Tanker Q&As and CIs on the IACS CSR Knowledge Centre

CI-T 1 Buckling assessment of corrugated bulkheads

CI-T 3 Cargo Tank/Local fine mesh FE Analysis Procedure in way of opening

Fig. B.3.3 Areas Requiring Fine Mesh Analysis on Deck, Inner and Outer Bottom Longitudinals

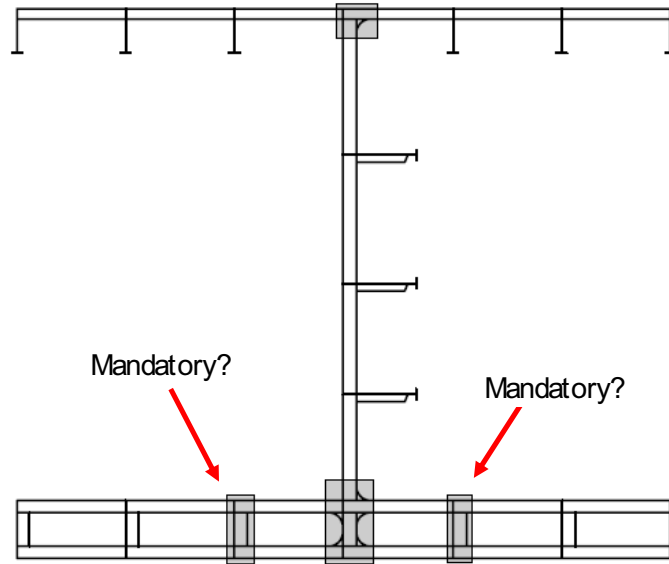
KCID No.	Ref.	Type	Topic	Date completed	Question/CI	Answer	Attachment
792 attc	Text B/3.1.4.2 & Figure B.3.3	Question	fine mesh analysis	2008/8/29	Appendix B/ 3.1.4.2 specifies that fine mesh analysis is required only for adjoining parts where deck or double bottom longitudinals are connected to transverse bulkhead stiffeners. However, Fig. B.3.3 shows that those areas requiring fine mesh analysis include the first floors next to transverse bulkhead as well as their adjoining parts. Please kindly clarify whether or not floors next to such adjoining parts (see sketch(C)) are also required to be evaluated by fine mesh analysis.	The assessment is only required for the end connections iwo transverse bulkhead and floors next to the transverse bulkhead. See also description of modelling in Appendix B, 3.2.4.	Y
813	Table B.3.1	Question	shear stress connections	2008/8/29	Reference is made to KC No.715 regarding shear stress corrections for screening criteria. Although the understanding of the questioner is deemed clear and reasonable, the answer given in the KC had caused us further confusion. Please confirm if the following interpretations on this matter are correct. (1)The screening criteria given in Table B.3.1 are applicable to openings in cases where geometry is not required to be represented in the cargo tank FE model. Such criteria are also applicable to web plates whose thickness is not reduced because their openings are too small to reduce the thickness in accordance with Table B.2.2. ($h_0/h < 0.35$ and $g_0 < 1.2$) (2) In cases where thickness is reduced in accordance with Table B.2.2, element shear stress τ_{XY} is to be adjusted by multiplying the ratio = $t_{mod_net50} / t_{w_net50}$. t_{mod_net50} : reduced web thickness in accordance with Table B2.2. t_{w_net50} : actual net thickness of web. (Note) The current Note 2 of Table B.3.1 might bring another adjustment by multiplying the ratio = $t_{w_net50} / t_{mod_net50}$, which double counts the effect of shear area reduction due to openings and, therefore, should not be applicable.	(1): Yes. The screening criteria is applicable to small openings ($h_0/h < 0.35$ and $g_0 < 1.2$) in the shaded regions, see Figure B.3.1. Fine mesh analysis or evaluation based on screening criteria given in Appendix B/3.1.6 is not required for openings in un-shaded regions if, $h_0/h < 0.46$ and $g_0 < 1.2$, and each end of the opening forms a semi circle arc (i.e. radius of opening equal to $b/2$). Item (2): See Appendix B/2.7.2.4. Your note: Current Note 2 is proposed re-written in line with KC ID 715.

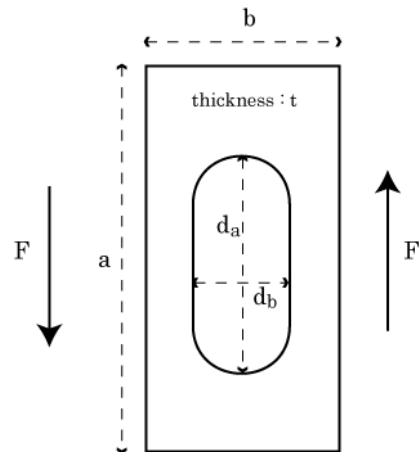
1. In CSR for Tankers, the critical shear stress τ_{cr} derived by the following formulas according to Case 6 of Table 10.3.1 takes into account reducing strength due to an effective cross sectional area reduction for shear in addition to the effects of a buckling strength reduction due to an opening.

2. Therefore, if shear force F acts on panels with an opening, a working shear stress τ_{work1} calculated by the following formula should be compared with the critical shear stress τ_{cr} .

In this case, τ_{work1} is taken as the mean shear stress for the whole panel including the opening (red part).

3. However, in the common interpretation CI-T3, a shear stress correction taking into account the stress increase due to the opening in accordance with Table PR1 is required. This means that if shear force F acts on panels with an opening, the working shear stress τ_{work2} is derived by the following formula and is compared with the critical shear stress τ_{cr} in consideration of an effective cross sectional area reduction due to the opening.

In this case, τ_{work2} is taken as the mean shear stress for the red part where stress increases due to the opening.

We feel that the effective cross sectional area reduction due to an opening may be considered twice in the assessment procedure according to CI-T3 and this is too strict.

4. Our understanding is that working shear stress should be assessed by the assessment procedure in 2 above.
